REMEDIATION SYSTEM EVALUATION

REILLY TAR & CHEMICAL CORP. (INDIANAPOLIS PLANT) SITE  
A.K.A. "REILLY INDUSTRIES" SITE  
INDIANAPOLIS, INDIANA

Report of the Remediation System Evaluation,  
Site Visit Conducted at the "Reilly Industries" Superfund Site  
October 28, 2003

EPA 542-R-04-035  
February 2004  
[www.epa.gov/tio](http://www.epa.gov/tio)  
[clu-in.org/optimization](http://clu-in.org/optimization)

**FIGURE 1. SITE LAYOUT AND SOURCES OF CONTAMINATION.**

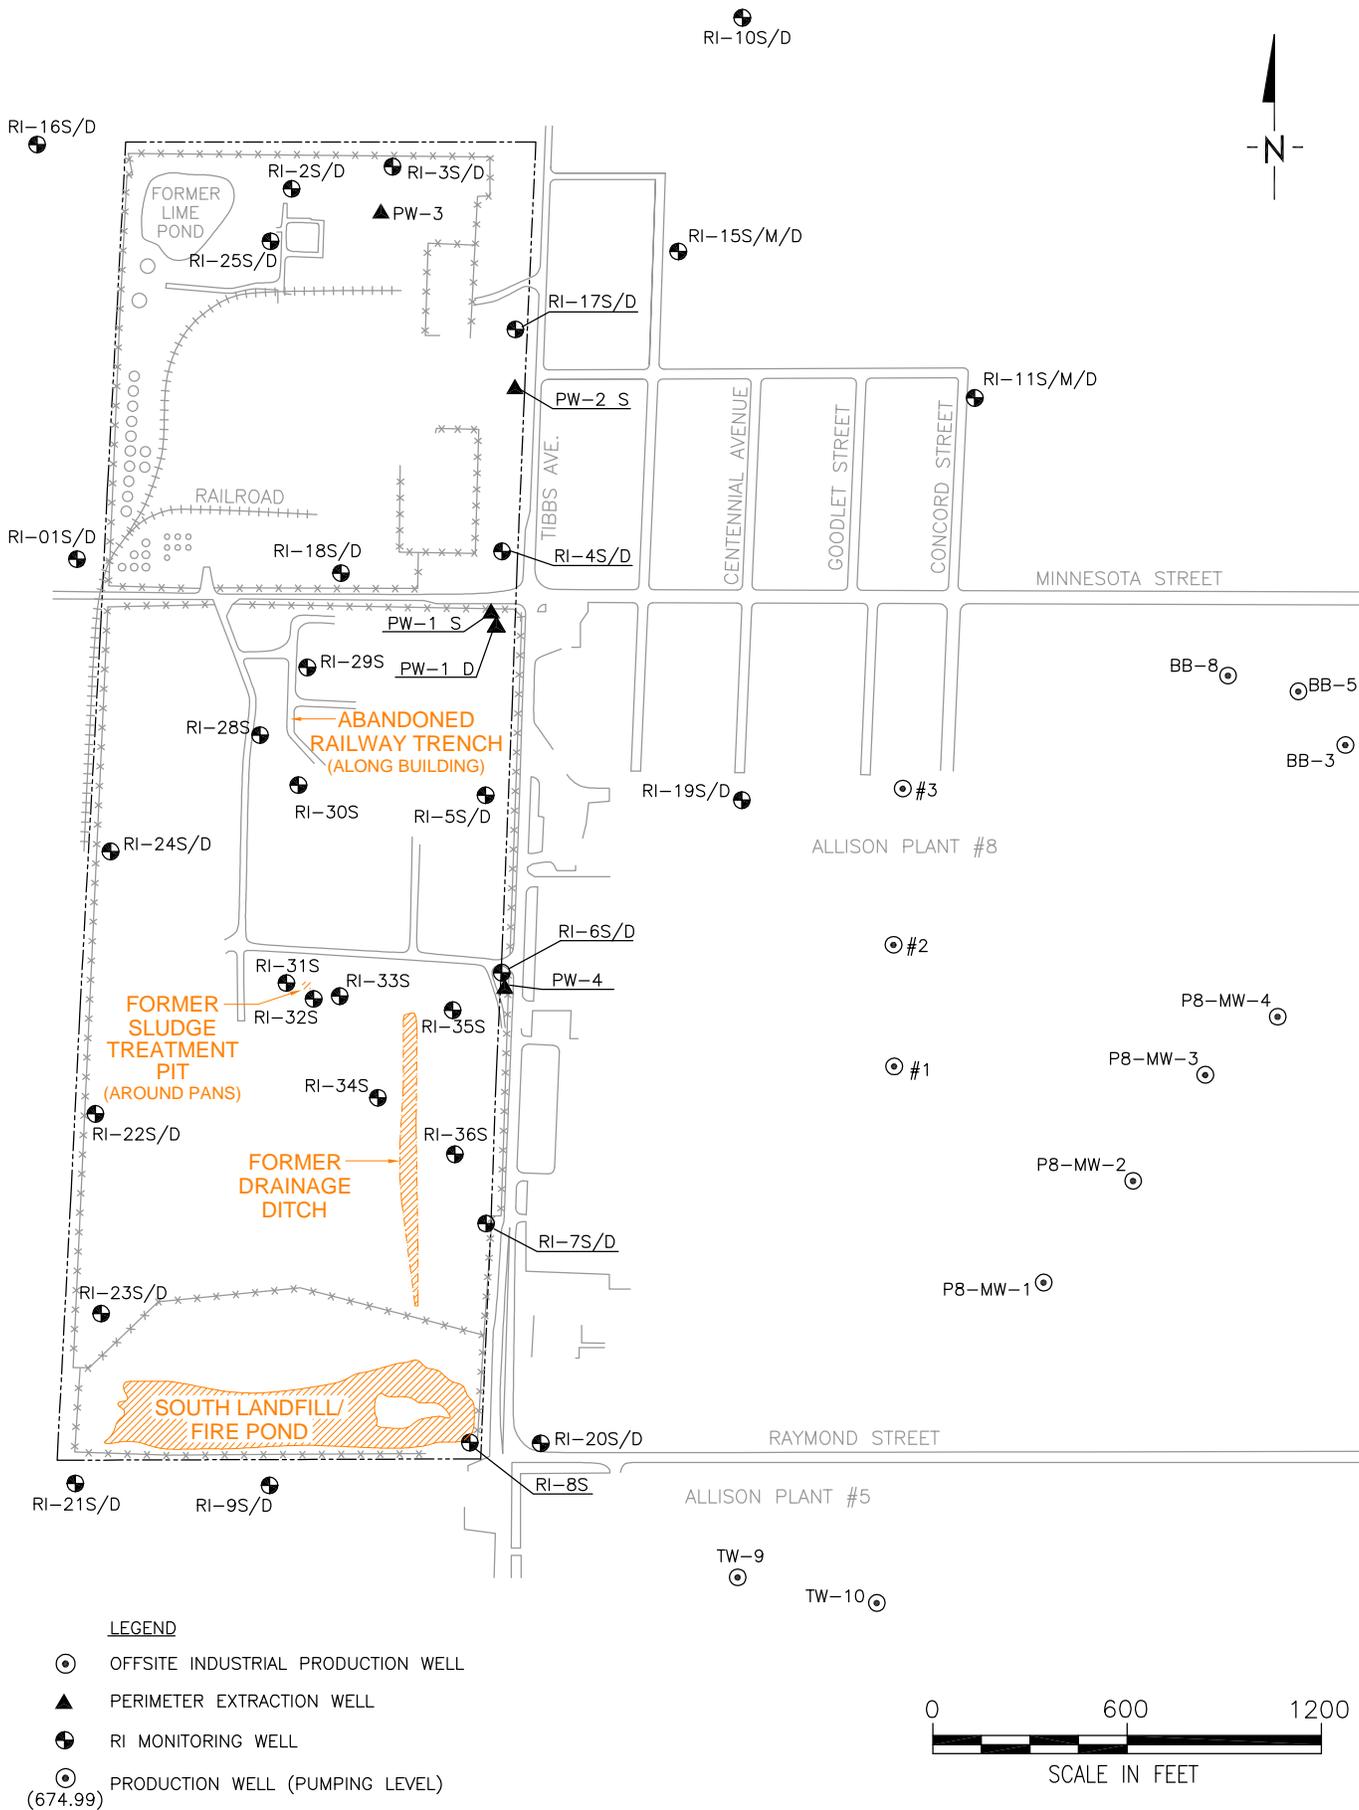
The portion of the eastern site boundary between extraction wells PW-1 and PW-4 is an area of particular concern with respect to capture effectiveness. These extraction locations are approximately 1,200 feet apart. Monitoring well RI-5S, located between these two extraction wells, had concentrations exceeding 500 ug/l for both benzene and total pyrdines in the last sample of 2002, and off-site well RI-19D (located downgradient of RI-5S) had concentrations exceeding 1,000 ug/l for both benzene and total pyridines in the last sample of 2002. The deep water levels at RI-4D (north of PW-1) and RI-5S (south of PW-1) are lower than surrounding wells, and indicate some potential for successful capture in the deep aquifer. However, the same cannot be said based on the water level map for the shallow aquifer, which is where most of the on-site contamination is found. Also, in both the shallow and the deep aquifer, there are not enough water level measurements immediately downgradient of the extraction wells to clearly delineate an actual capture zone.

FIGURE 2. SHALLOW WATER LEVELS, 3RD QUARTER FY03.

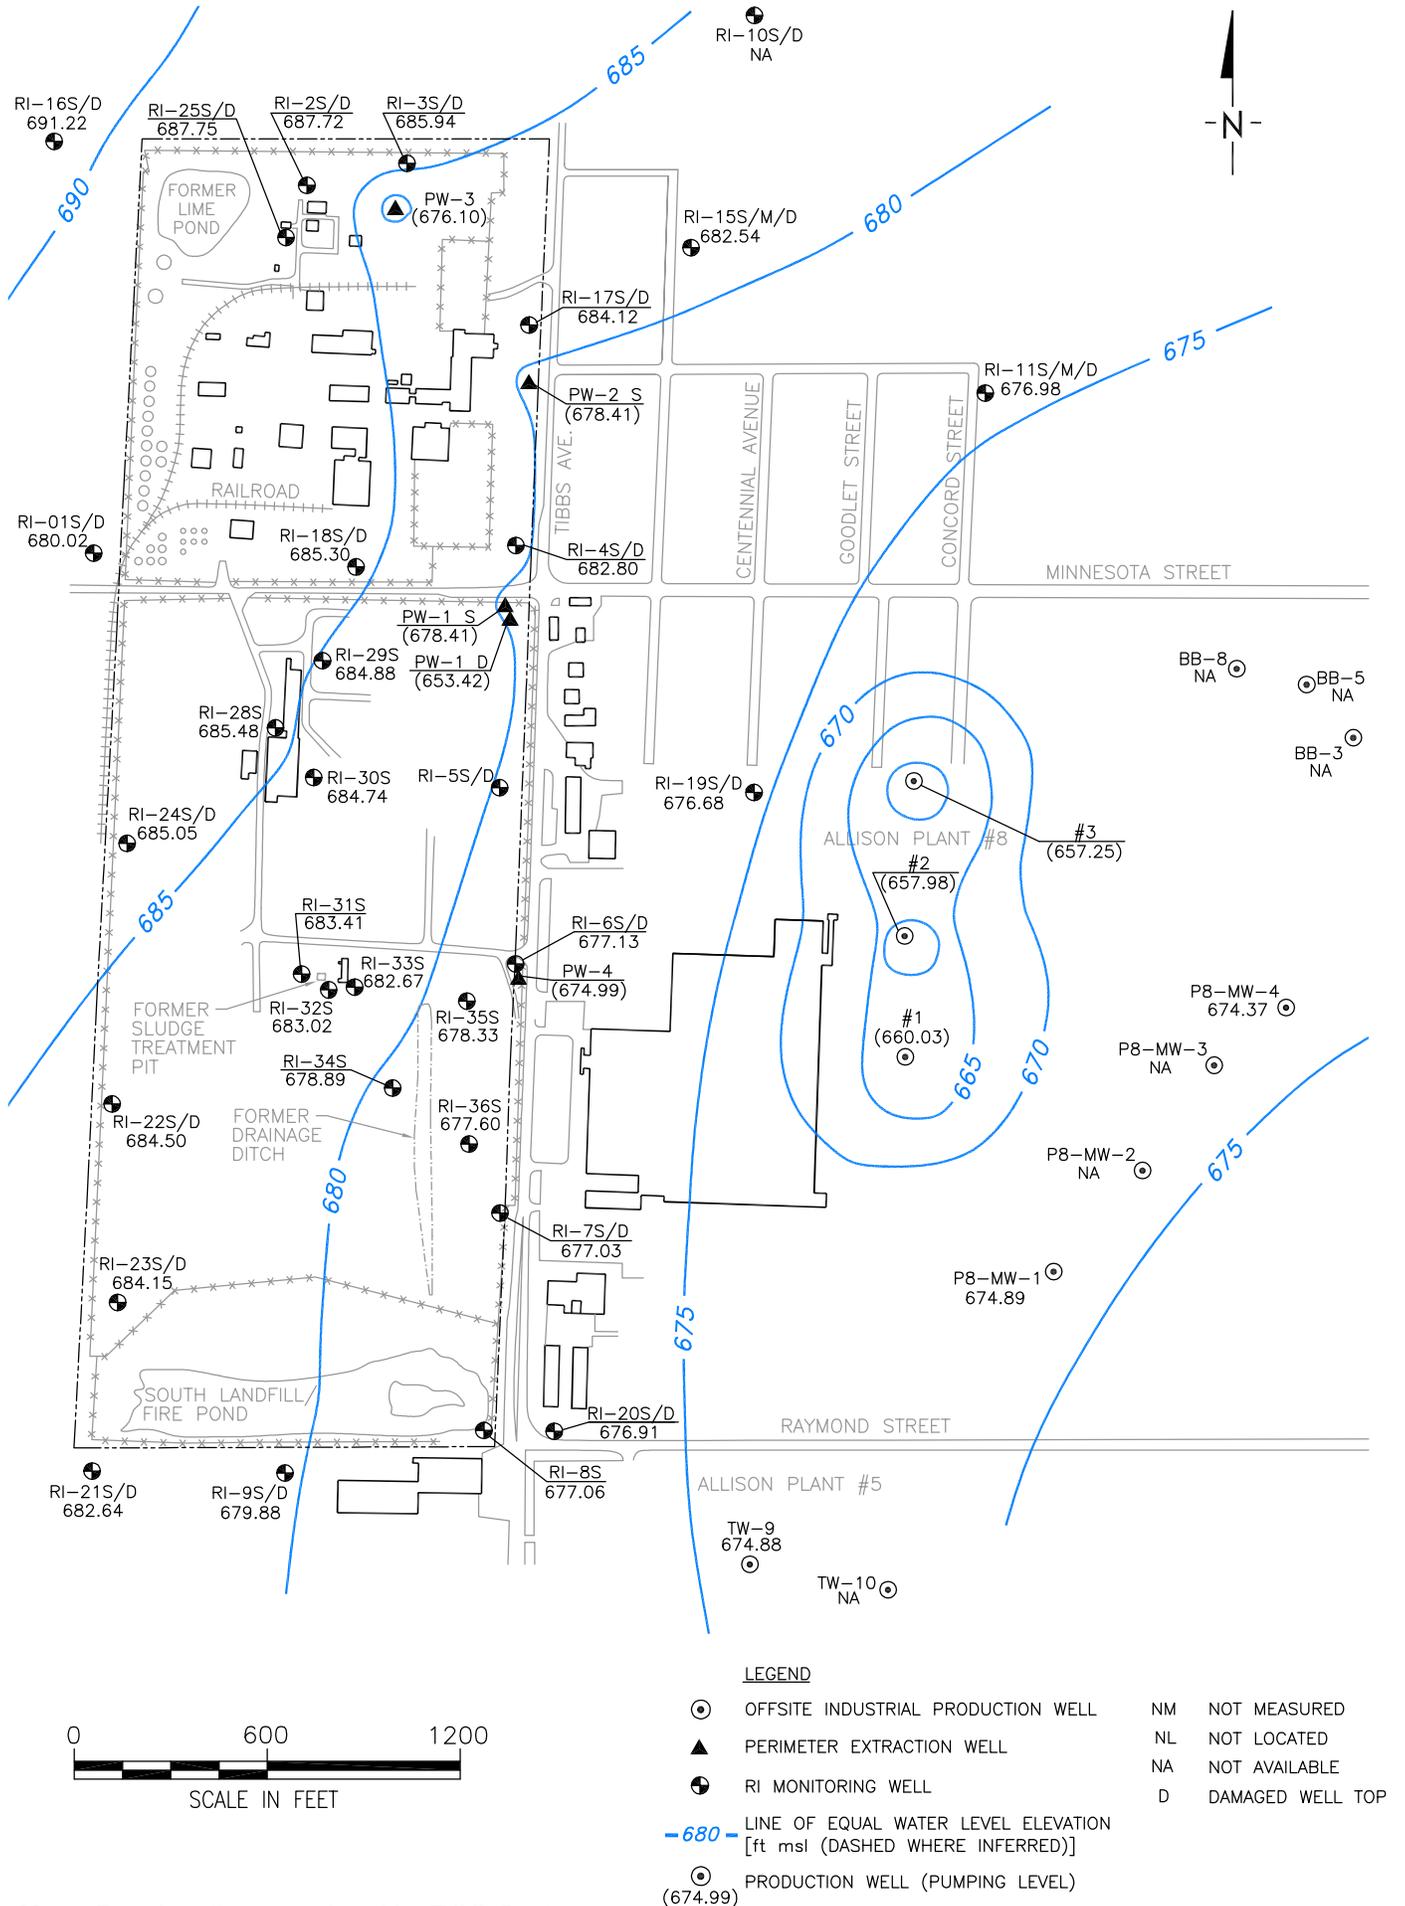
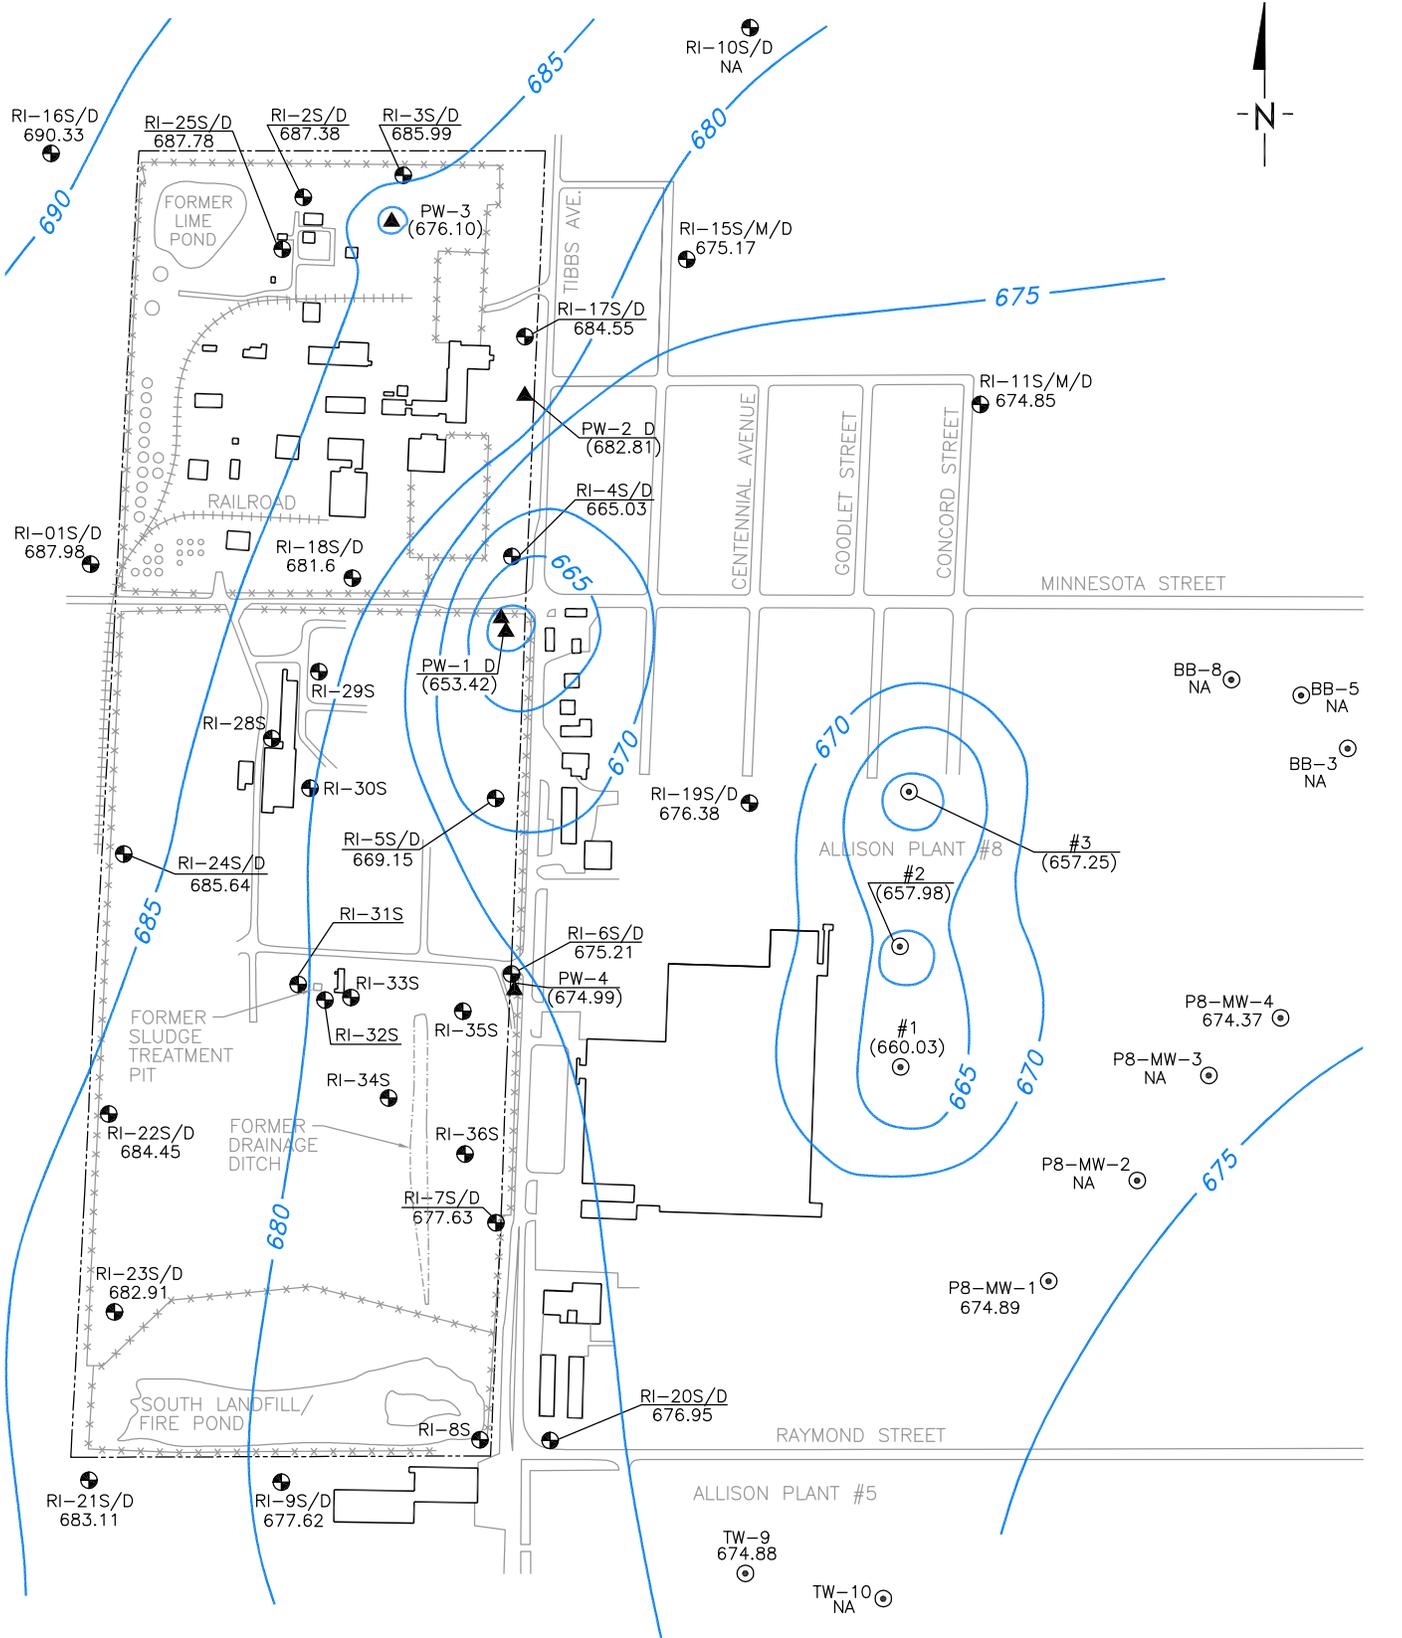
Water levels are measured quarterly, and potentiometric surface maps are produced quarterly. Figure 2 and Figure 3 illustrate water levels for the shallow and deep aquifers, respectively (the contours were interpreted by Environmental and Geological Consultants, Inc.). Ground water flow in both aquifers is generally to the east, and is influenced by on-site extraction (PW-1 to PW-4) and significant off-site extraction to the east. Note that the contours interpreted on those figures are based on water levels measured at the extraction wells, which are likely much lower than the surrounding aquifer material as a result of well losses. Without piezometers located near the extraction wells, the interpretation of water levels near the extraction wells is subject to considerable uncertainty, and extent of capture interpreted using such water levels may overestimated.

**FIGURE 4. WELLS WHERE LAST SAMPLE IN 2002 HAD MORE THAN 500 ug/L BENZENE AND/OR TOTAL PYRIDINES.**

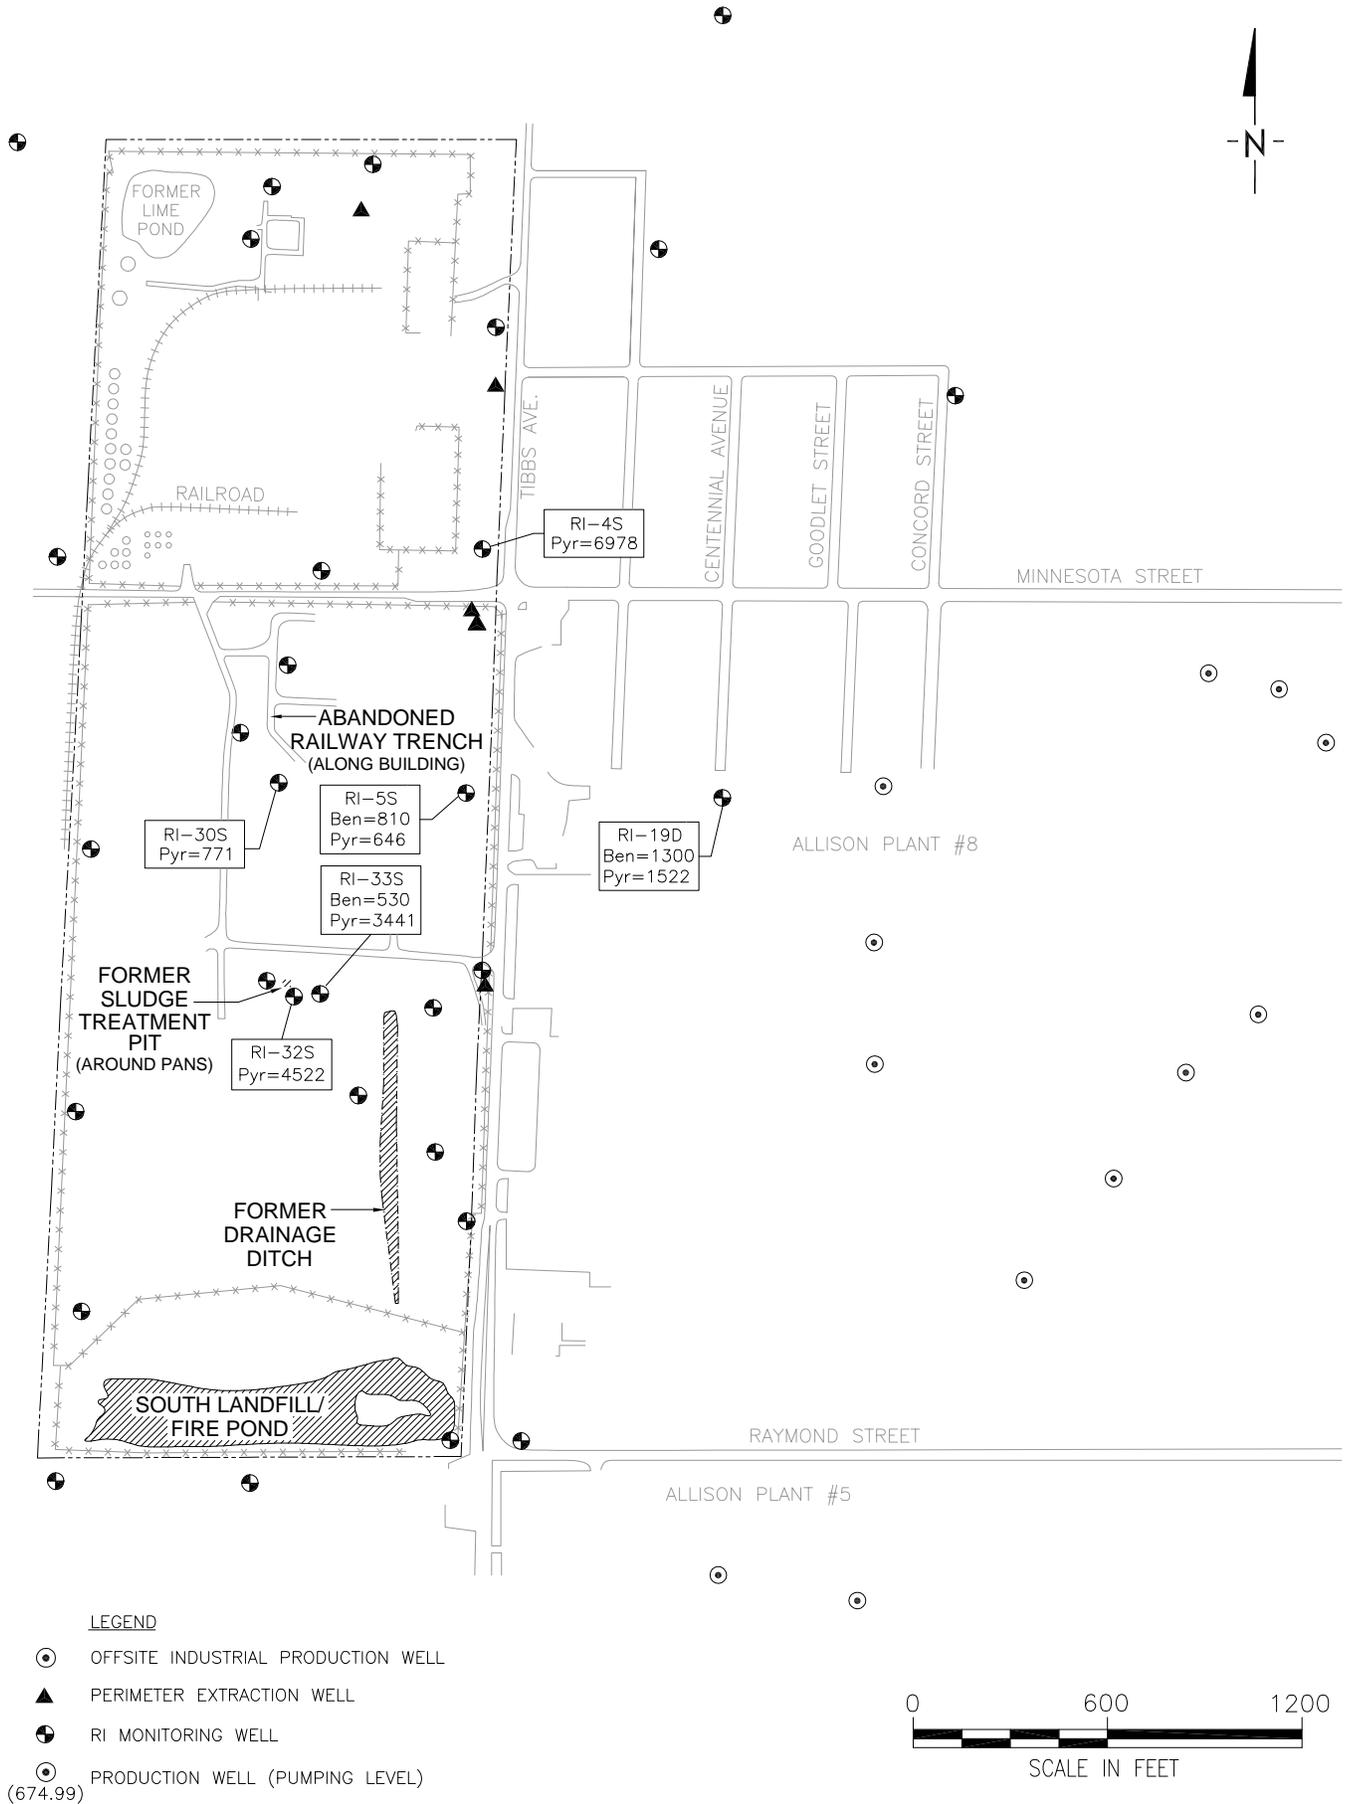
There are other wells located on-site and off-site where concentrations remain elevated at significantly higher concentrations than at the example wells listed above. Figure 4 illustrates wells where the latest sample in 2002 had benzene greater than 500 ug/l and/or total pyridines greater than 500 ug/l. These wells are summarized below:

The declining concentrations at many wells suggest that the remedies to date (P&D, SVE, excavation, etc.) have been successful at reducing continuing impacts to ground water, while the high concentrations that persist at some wells indicate there continue to be some on-site areas where sources of ground water contamination may remain, especially on the south property but potentially on the north property as well (e.g., there are no ground water monitoring points immediately upgradient of PW-4S). Well RI-19D is of particular concern because it is located off-site and has relatively high concentrations of benzene and total pyridines that increased to current values after initially decreasing to much lower concentrations between 1996 and 1998. Well RI-19D is also located in a potential “capture zone gap” between extraction locations PW-1 and PW-4, as discussed in Section 4.2.2.
